**TOWN OF WELLINGTON
PLANNING COMMISSION**

Date: March 6, 2023
Submitted By: Paul Whalen, Planner III
Subject: Site Plan Review - Connell Resources Asphalt Plant - South of County Road 66, West of BNSF Railroad

Connell Resources Asphalt Plant Site Plan Review – A parcel of land situated in NE ¼ Section 28, Township 9 North, Range 68 West of the 6th, P.M. Town of Wellington, County of Larimer, State of Colorado.

C001

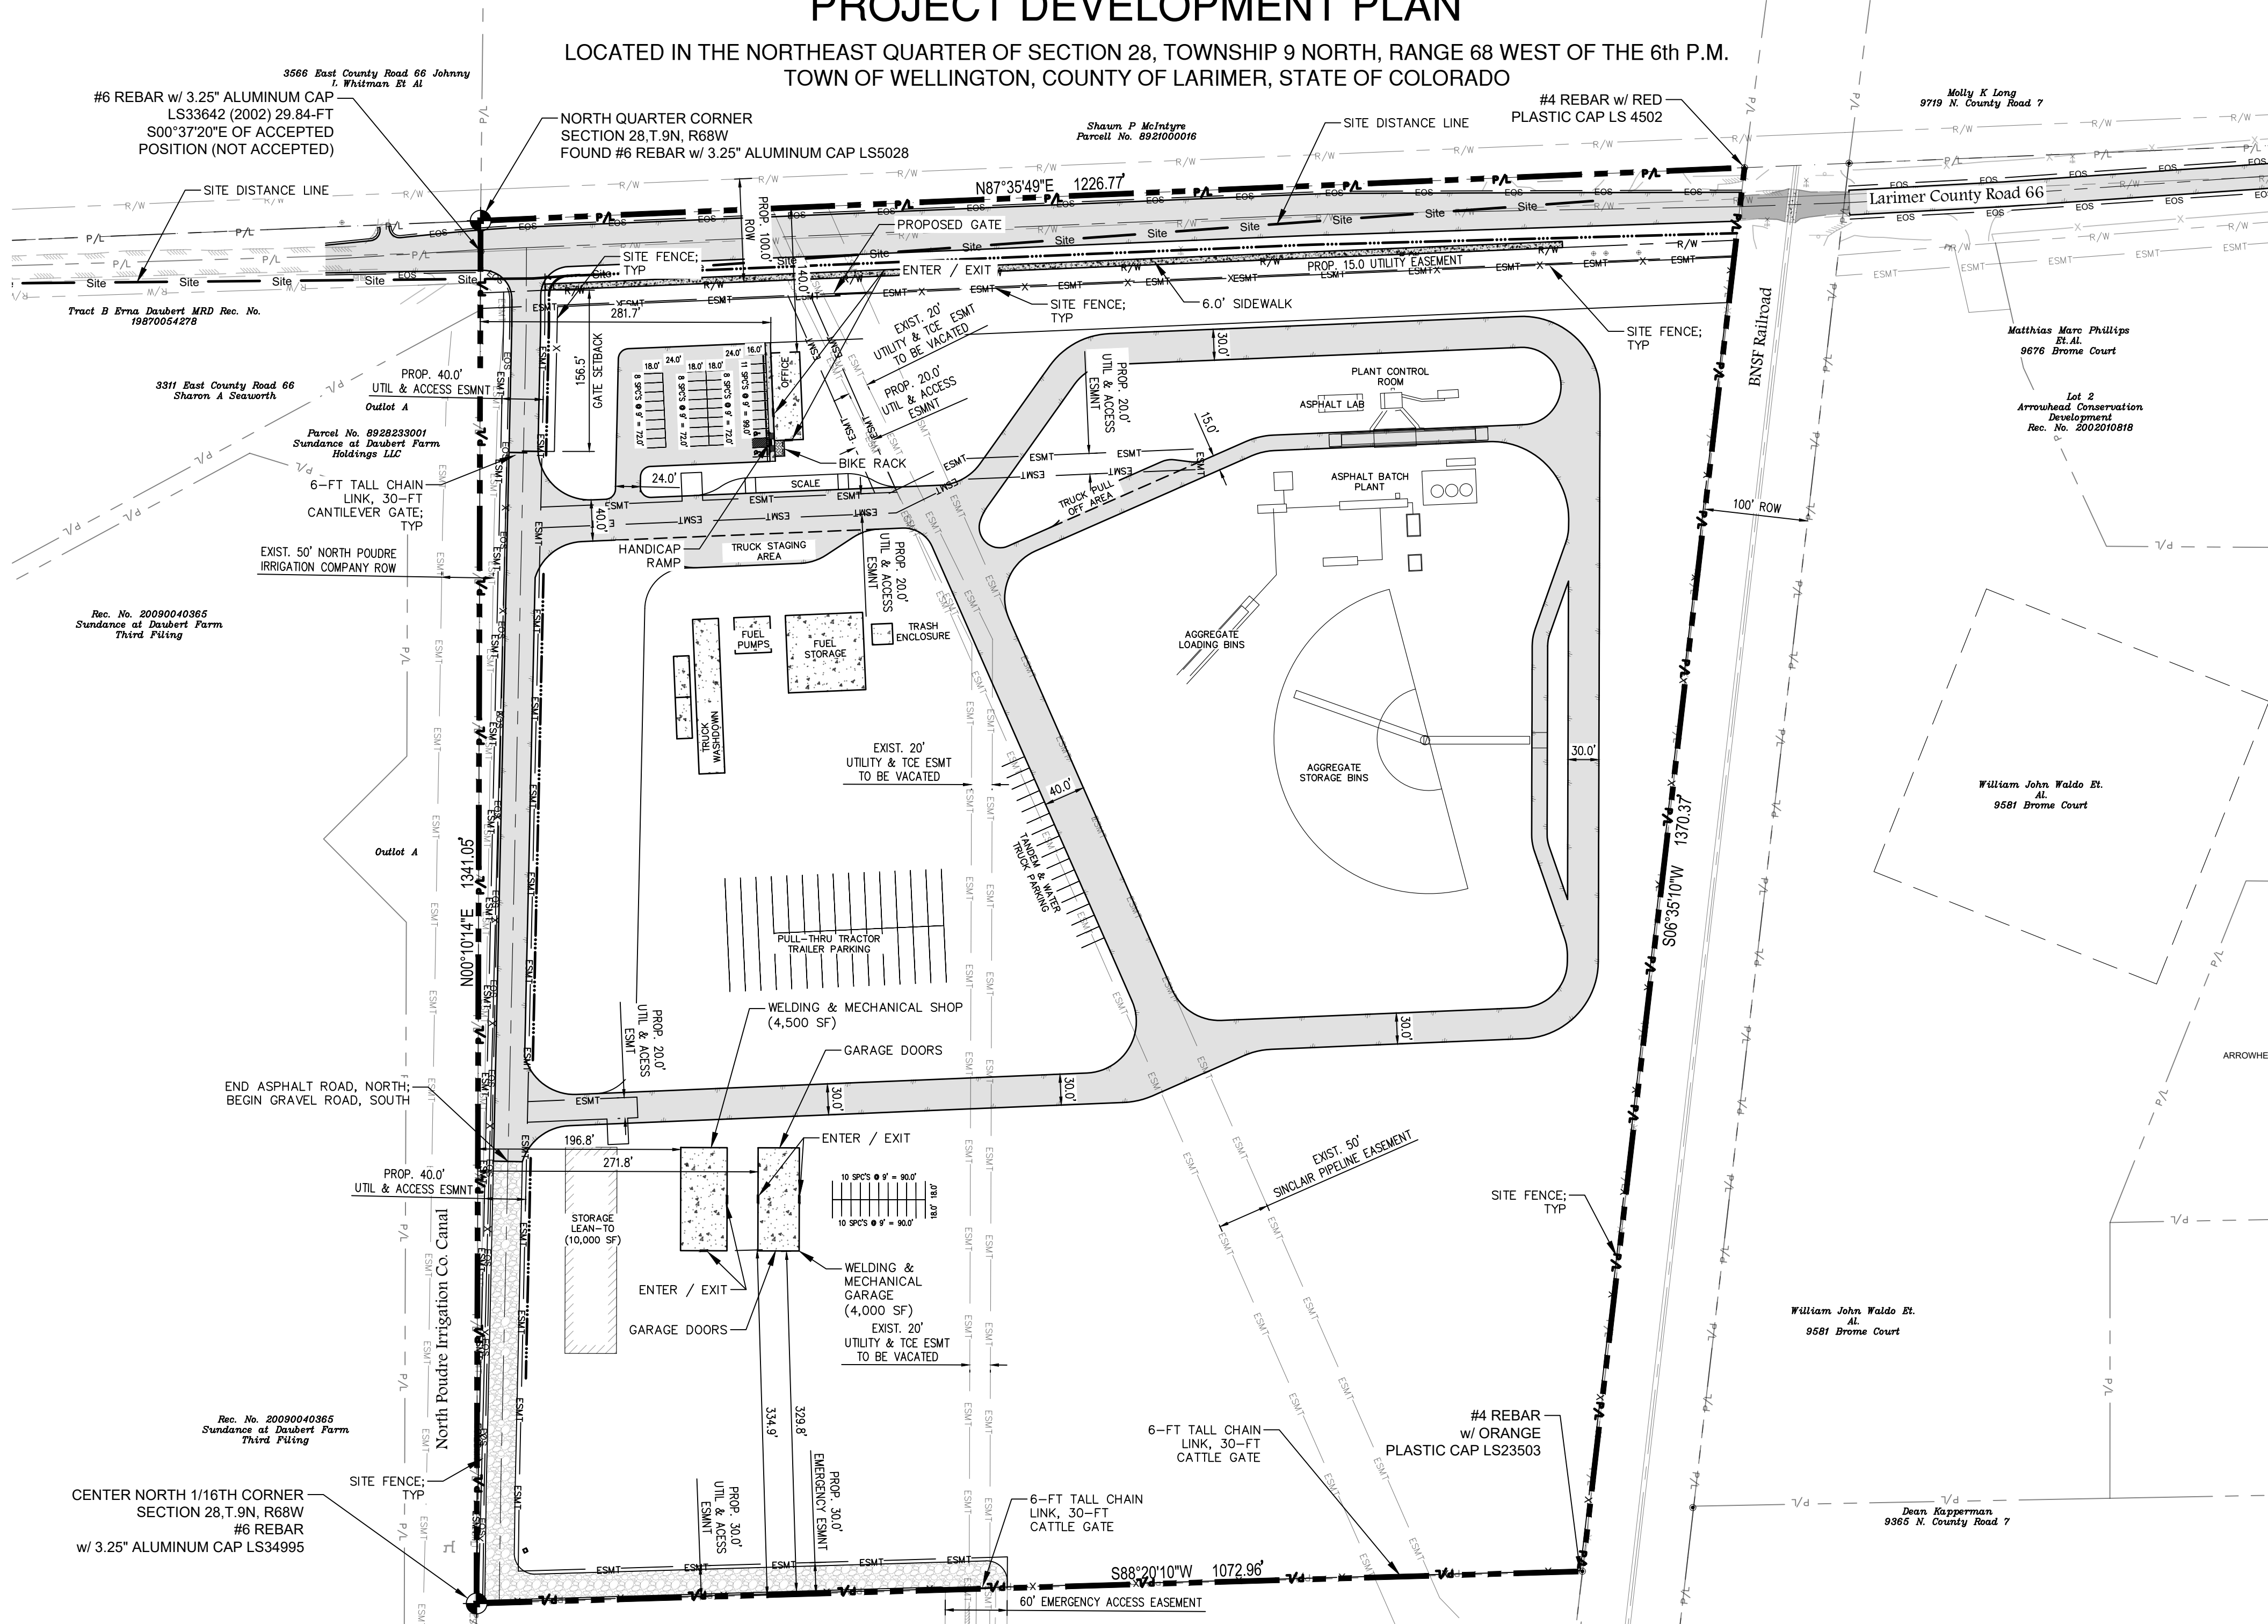
- Please revise the Sheet Index on sheet 1, and each individual sheet—...to coordinate sheet labelling, 1 of 34, 2 of 34, etc..., and sheet title blocks, for consistency throughout the plan set.

DEVELOPED DRAINAGE EXHIBIT

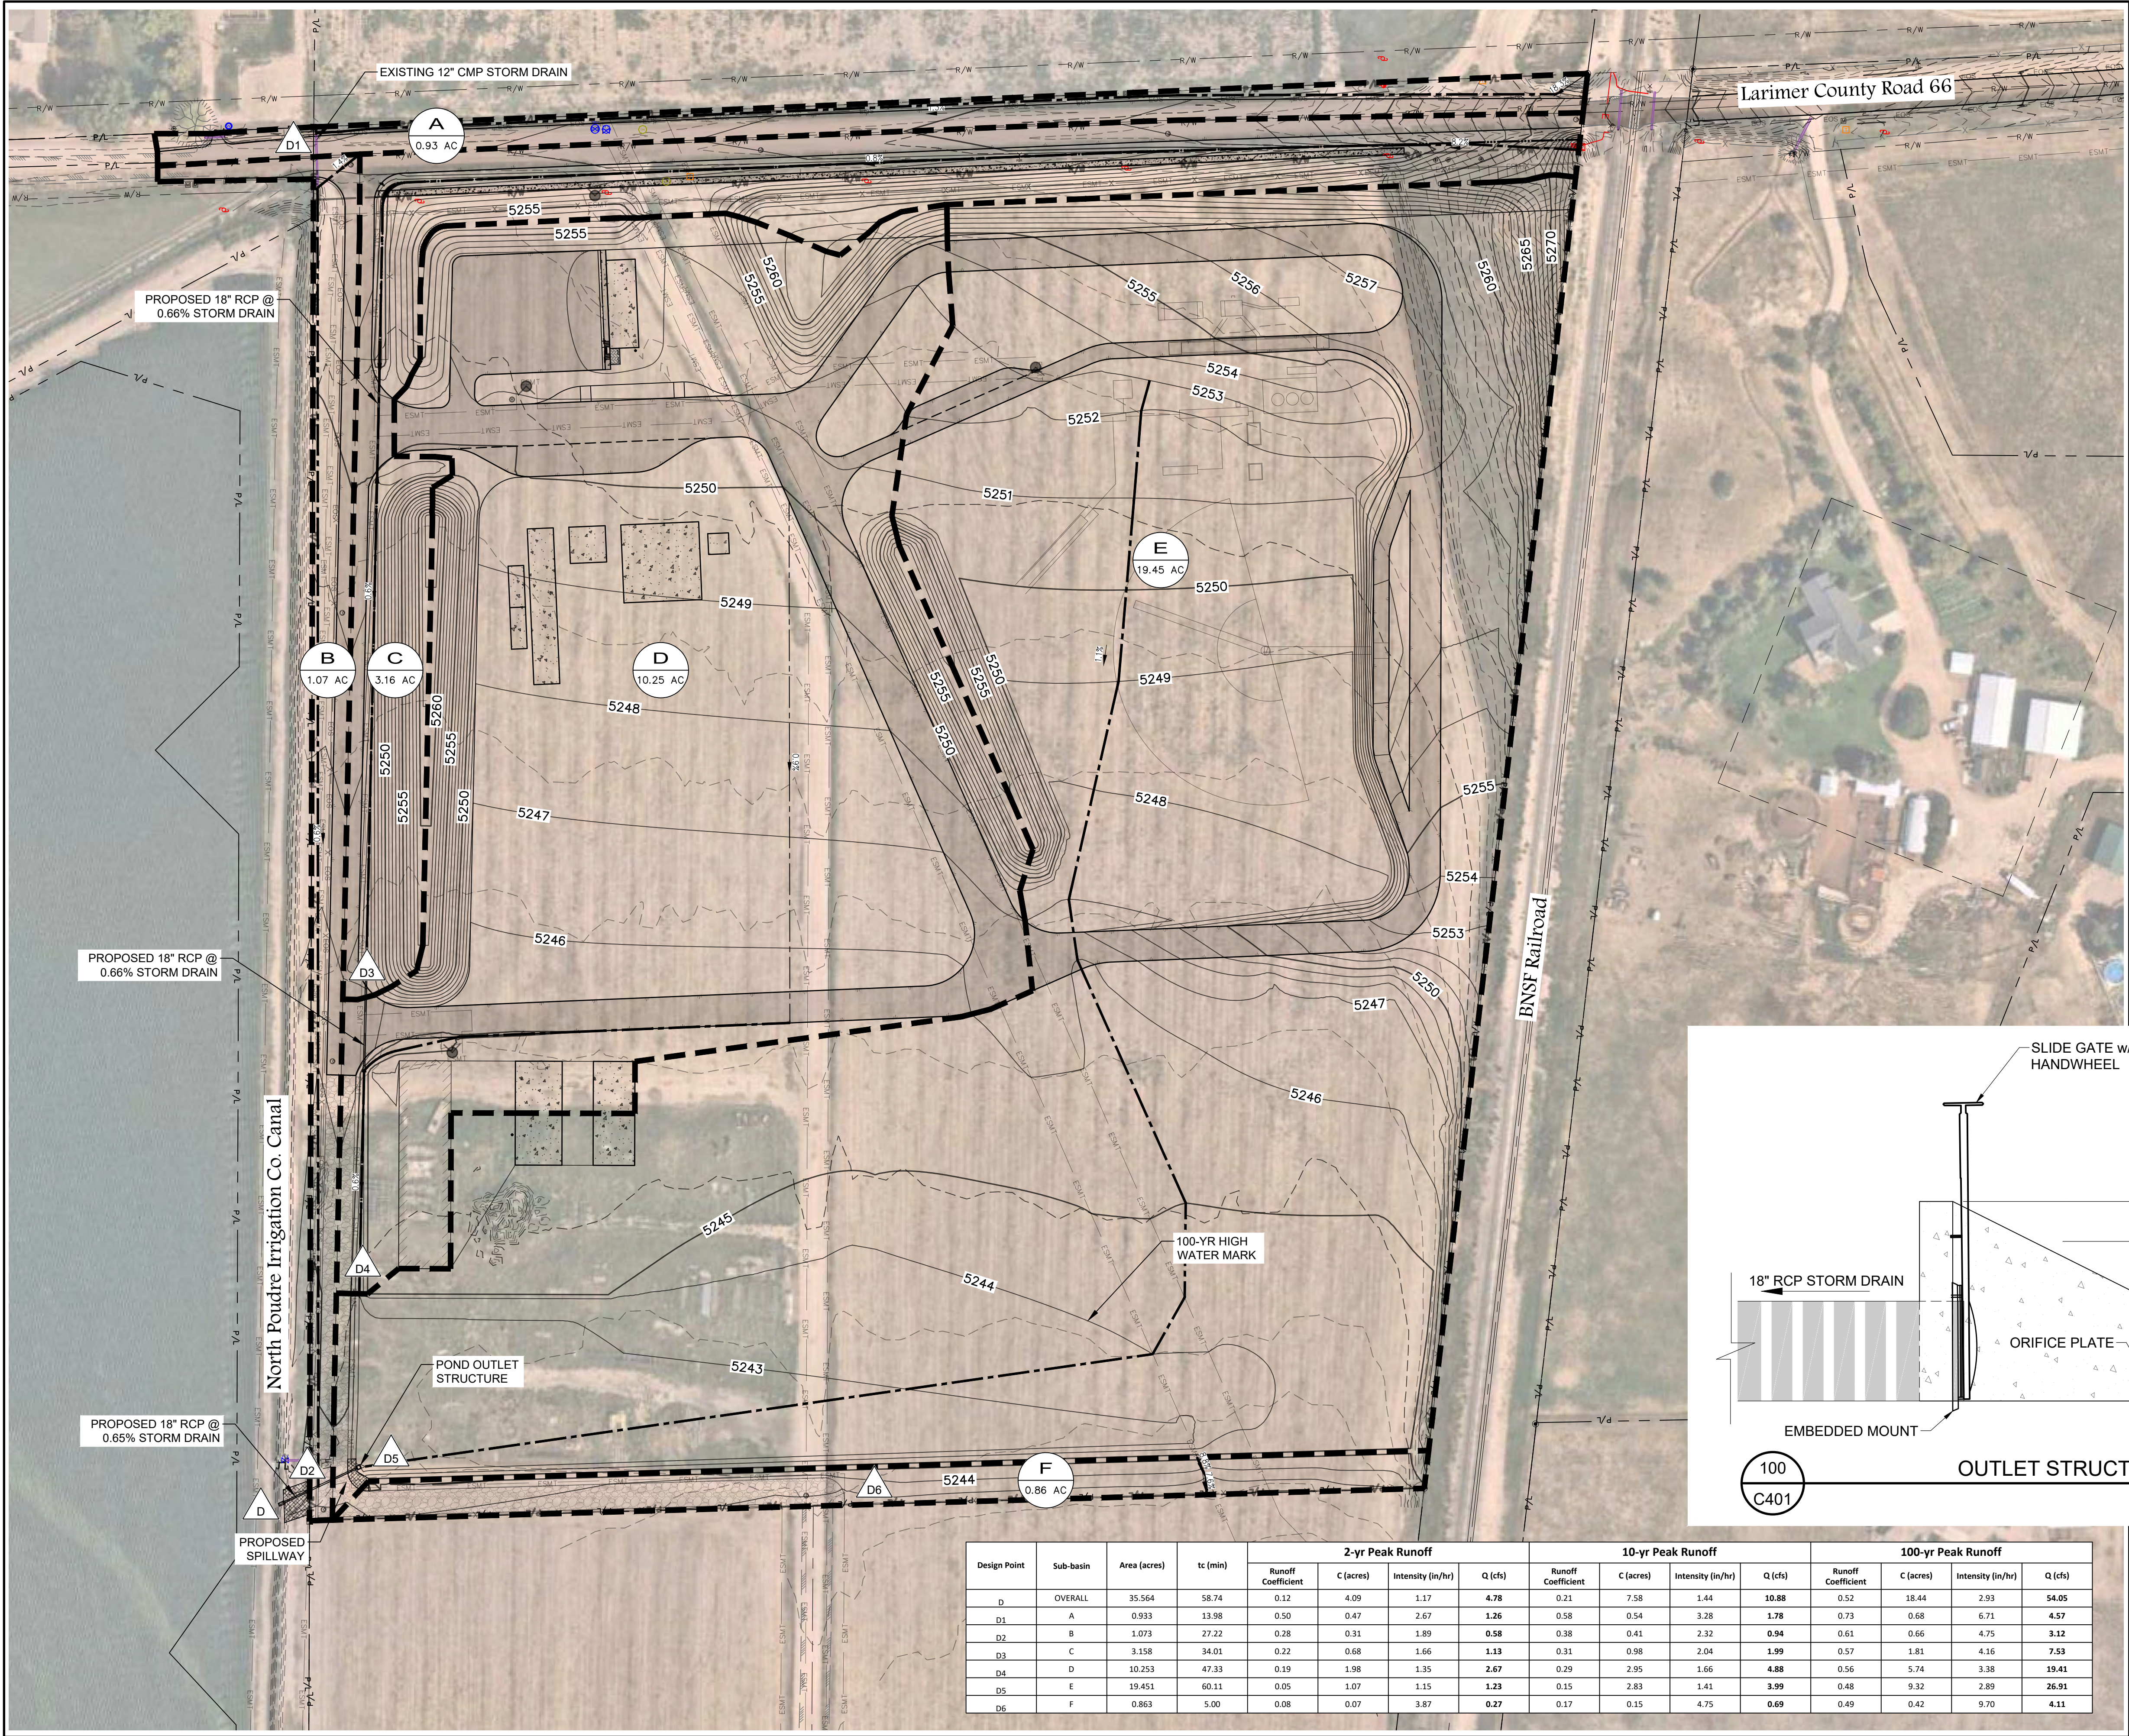
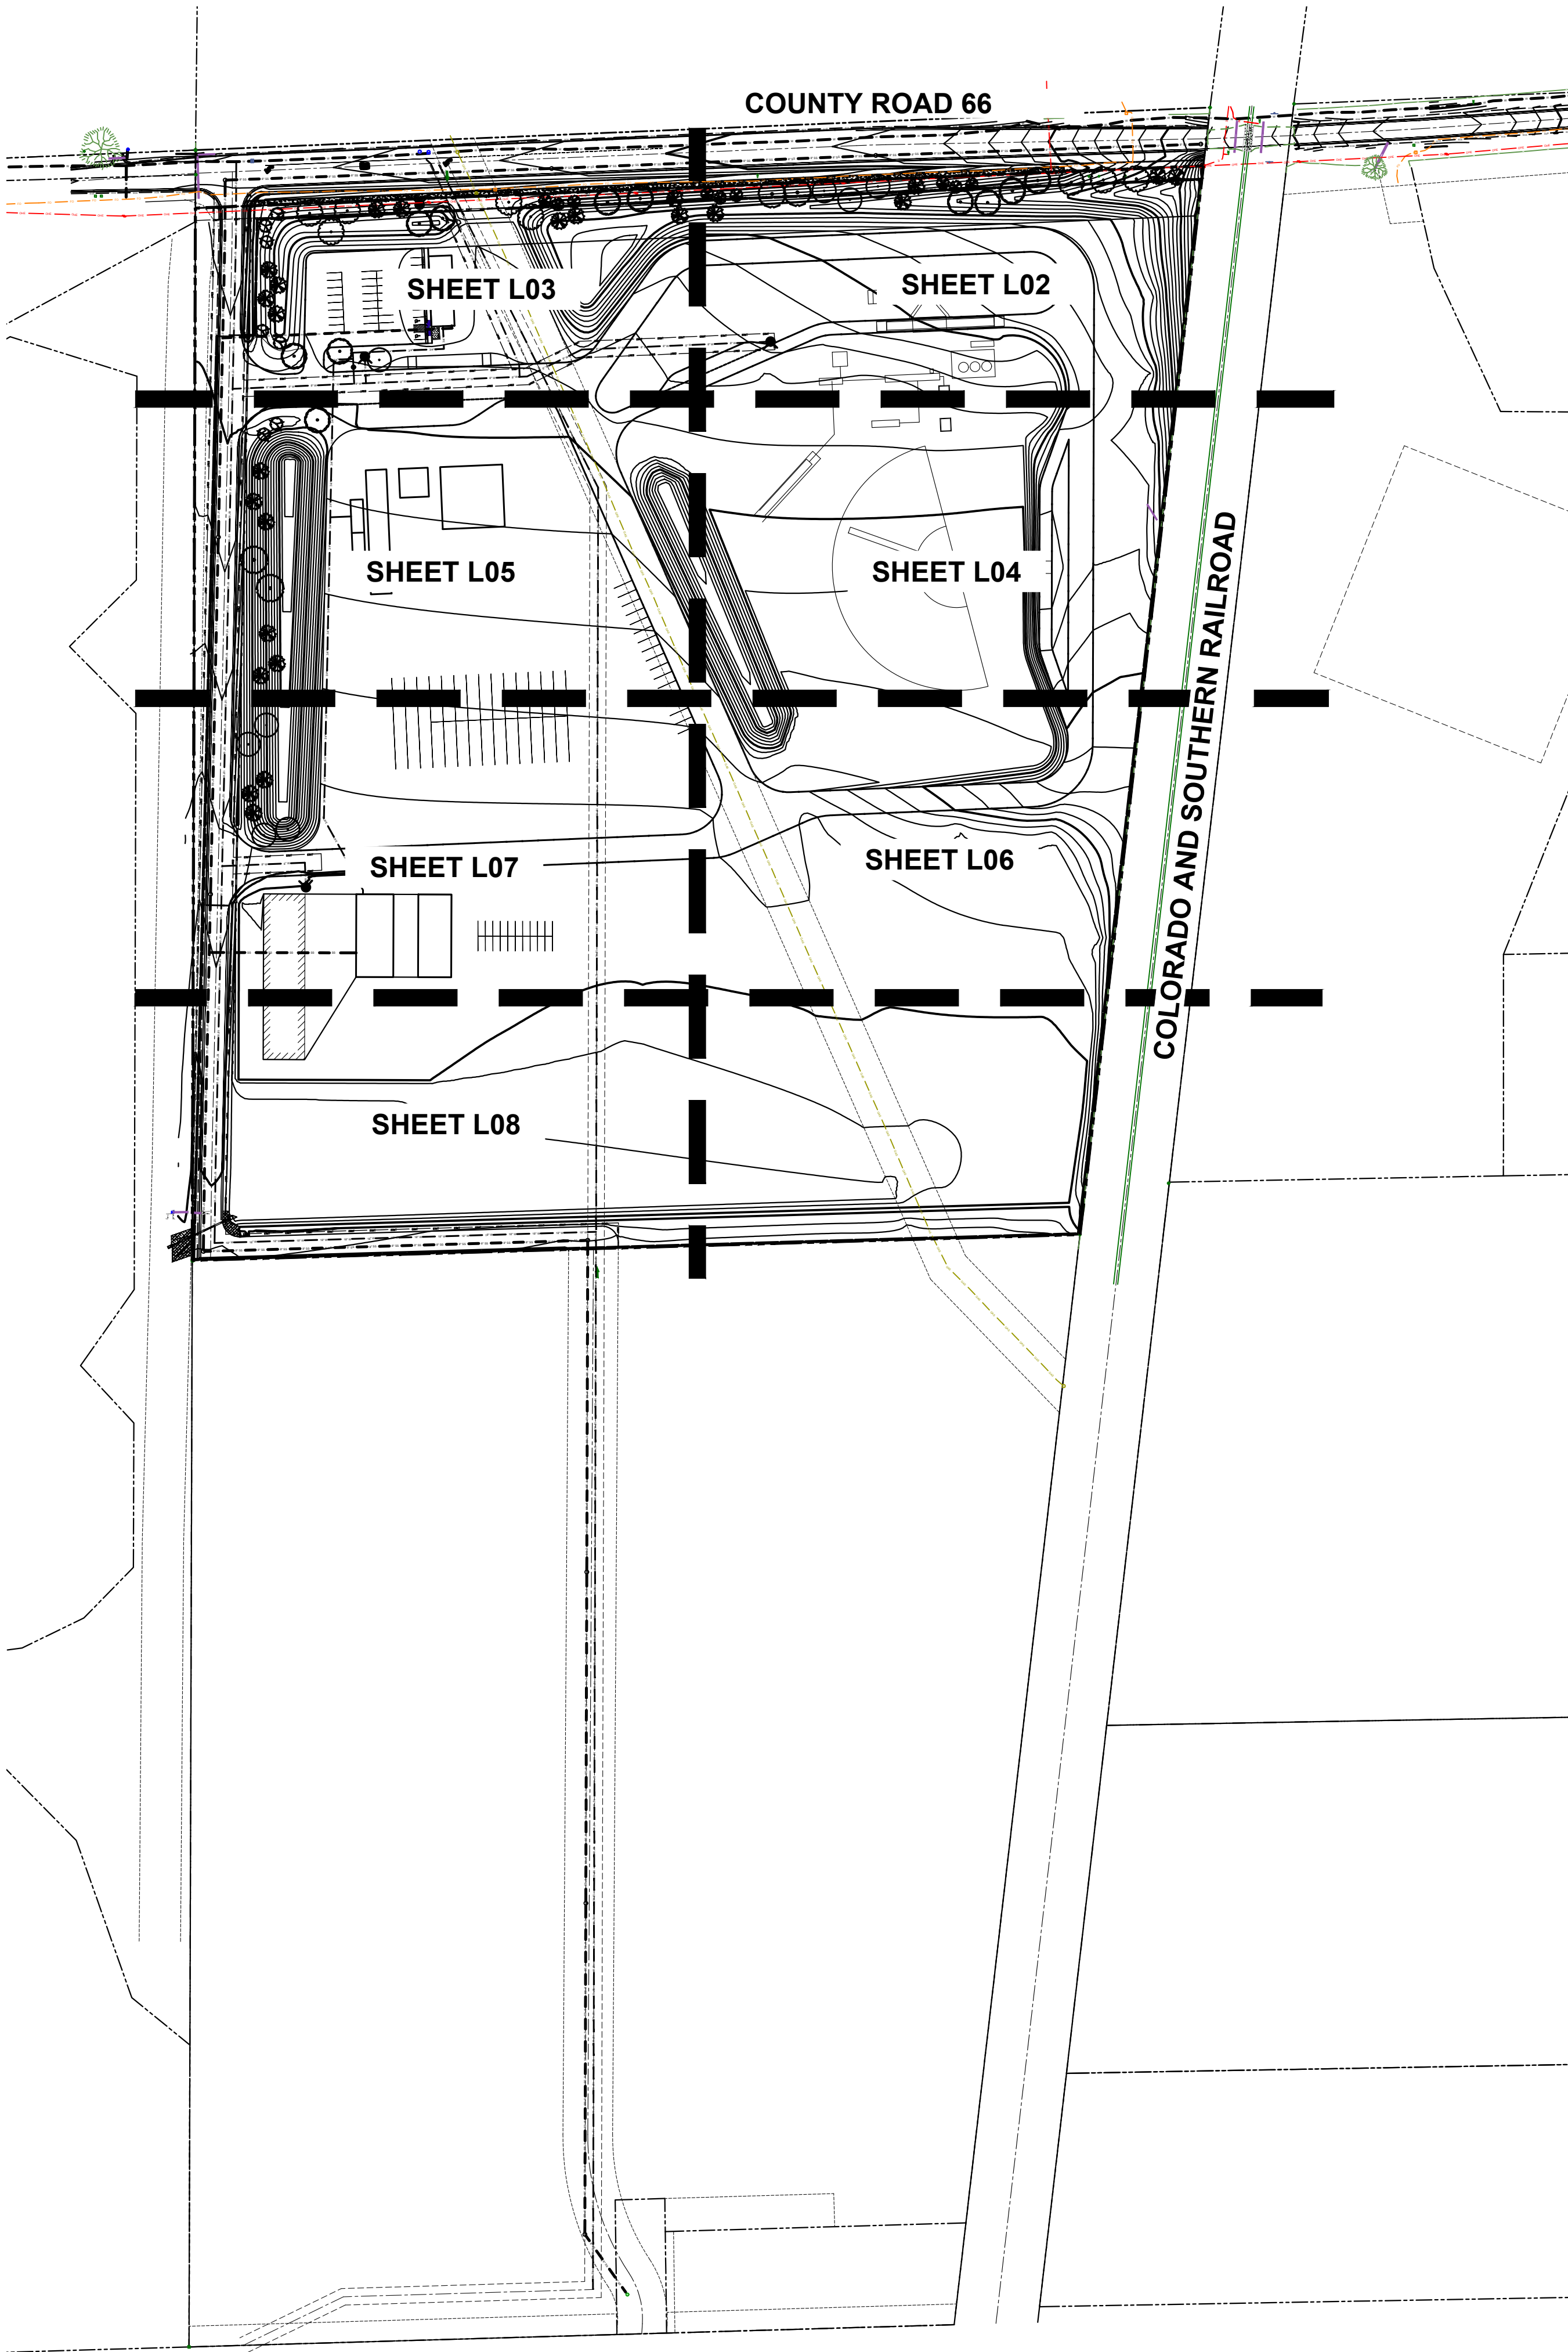
12. Drainage: The applicant has provided plans indicating proposed site grading and drainage patterns with details for staff review. The Public Works engineering team has reviewed the project with review comments provided for the applicant to address. The developed site with 35.56 acres indicates an approximately 18.1% impervious area. The drainage

report proposes surface flows across the property to a detention basin located in the southwest corner. The basin location in the lowest area of the property, conflicts with the required earth berm which must be relocated. An on-site drainage network conveys the storm water flow via swales and culverts to the detention pond which then flows into the North Poudre Irrigation Company ditch on the west-side of the future W 1st Street. Any required site modifications shall be addressed in a final drainage plan & report in accordance with Planning and Public Works.
